Staff Report Plan Commission Meeting – May 16, 2023

Applicant:	Luigi Randazzo,
	Keystone Planning
	and Design
Property	Thomas C. Zylstra
Owner:	Farms, LLC
Location:	Approx. 500ft. south
	of W. Main St. and
	Randall Rd.
	Intersection
Purpose:	Develop animal
	hospital on the
	property
Application:	PUD Preliminary
	Plan
Public Hearing:	Not required
Zoning:	BR Regional
	Business, Zylstra
	PUD
Current Land	Vacant Lot
Use:	
Comprehensive	Corridor/ Regional
Plan:	Commercial

Review the PUD Preliminary Plan.

COLOR ELEVATIONS

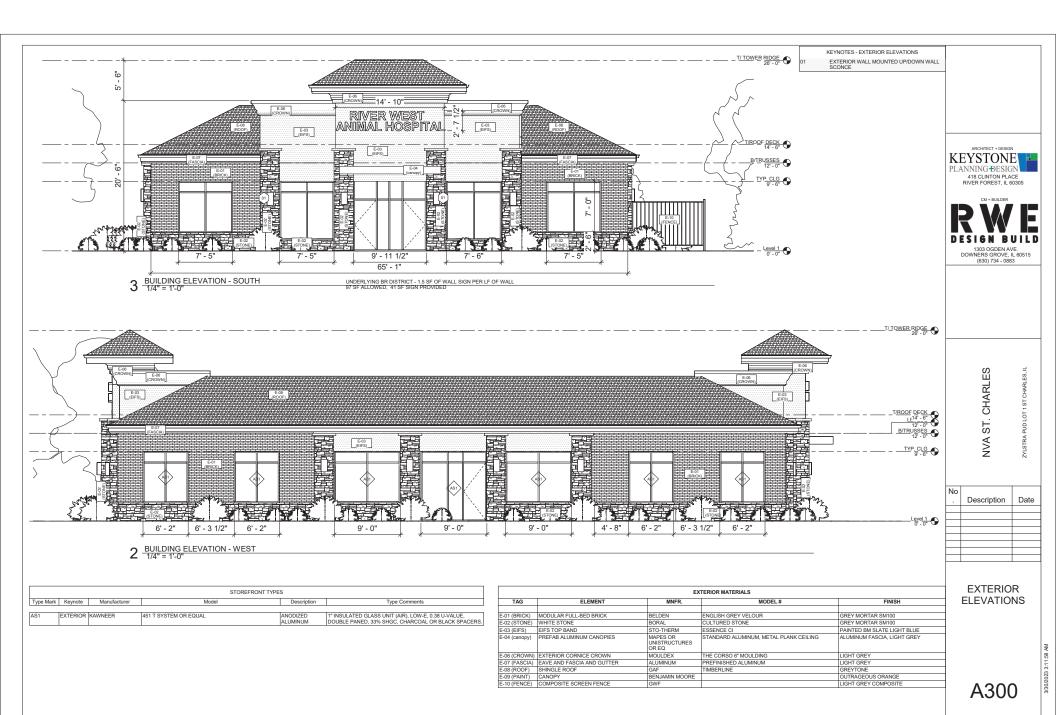
Staff Comments:

✓ The design elevations meet the Design Standards found in the Zylstra PUD and Chapter 17.06 of the Zoning Ordinance.
